March 12, 2021

Re: **Nantucket Shores (PWS ID #95088)**  
**2017 Well #2 (SRC-AB) – TILL52714, L123440**  
**Conditional Approval (PR #68-2017)**

Evan Hofeld, Regional Engineer  
OHA - Drinking Water Services

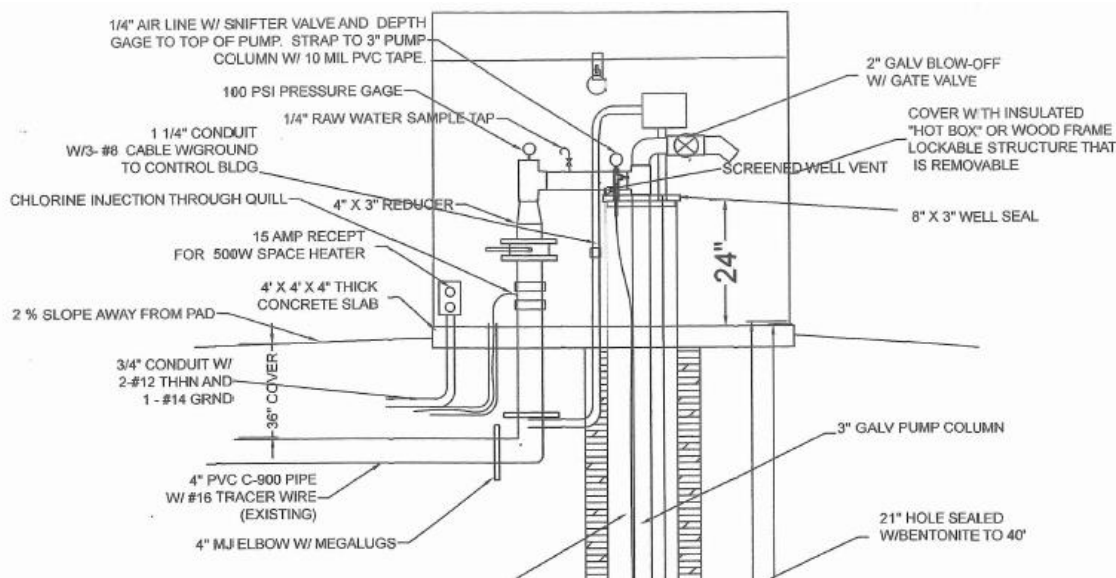
1. A single set of raw (untreated) water quality data including coliform bacteria, [IOCs](#) (including nitrate, nitrite and arsenic), [SOCs](#), [VOCs](#), and radionuclides (gross alpha, radium 226/228 and uranium) are submitted. These are to be taken from the new well's raw water sample tap at the wellhead. Your existing lab (Waterlab) should be able to assist you with this sampling.
2. Plans are submitted that show the above-ground wellhead structure detail including the well house, concrete slab, drainage, pump-to-waste piping, flowmeter (totalizer and/or rate of flow), and plans, specifications, and/or photos showing the wellhead and how it is connected to the water system. The original submittal is shown in the image below:
